## Report\_A7000-a\_USR\_S120\_1502091742\_MP6.V3\_LENOVO6752\_BMAIN\_ROW\_v\_3-3

**Date 16.02.2014**

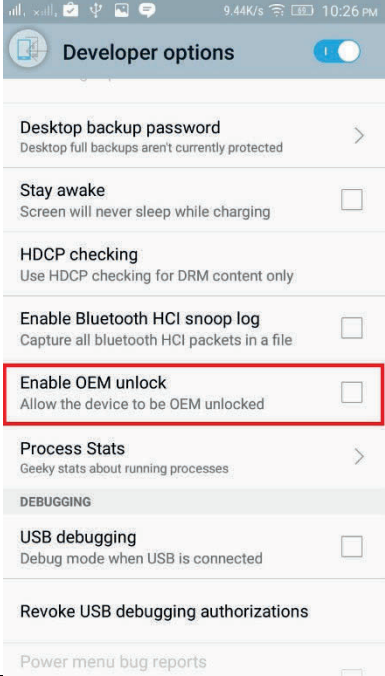
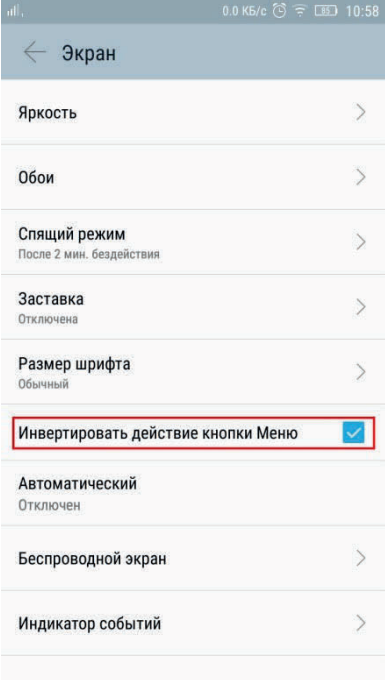
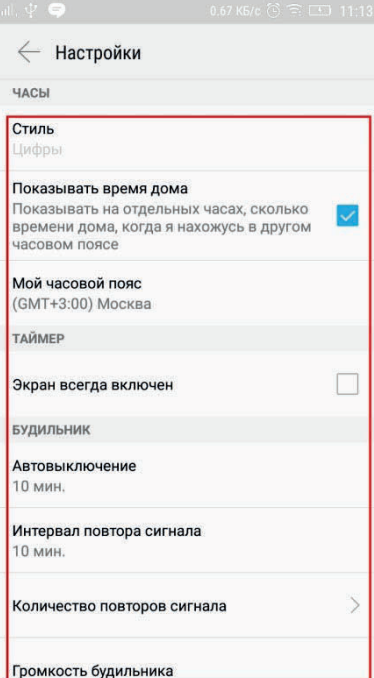
No	Status	Change from	Change to	Location	Screenshot
<b>Critical</b>					
0-1	<b>Critical</b>	Bad work autocorrecting ISO by video recording & photo shooting in the poorly lit room. The effect of oil paint (snow, noise) on video and photo without flash. See to the red quadrate in our picture.	<a href="ftp://lenovoFT@59.61.88.220/6.Project/AIO_ROW/RU_UT/Round2/IMG_20150216_194132.jpg">ftp://lenovoFT@59.61.88.220/6.Project/AIO_ROW/RU_UT/Round2/IMG_20150216_194132.jpg</a>	Camera app - Poorly lit room – Video recording & Photo shooting - auto ISO	
1	<b>Critical Not fixed</b>	DUT have a very long delay (incoming call) Steps: Call to dut from reference On reference I can hear the active call (long signals - no one picks up the phone) but DUT not showed the active incoming call Temporary after end of call (LTE auto mode) DUT is out of the network, but showed the Full antenna signal into notification panel)	Video: <a href="ftp://PhoneUT@54.215.6.167/data/ftp/PhoneUT/PhoneUT/AIO_ROW/RU_UT_R eports/3_report/Call_incoming_issue_VI D_20150214_194159.mp4">ftp://PhoneUT@54.215.6.167/data/ftp/PhoneUT/PhoneUT/AIO_ROW/RU_UT_R eports/3_report/Call_incoming_issue_VI D_20150214_194159.mp4</a> Logs: <a href="ftp://PhoneUT@54.215.6.167/data/ftp/PhoneUT/PhoneUT/AIO_ROW/RU_UT_R eports/3_report/Call_incoming_issue_m tklog.zip">ftp://PhoneUT@54.215.6.167/data/ftp/PhoneUT/PhoneUT/AIO_ROW/RU_UT_R eports/3_report/Call_incoming_issue_m tklog.zip</a>	Call to DUT- the long delay
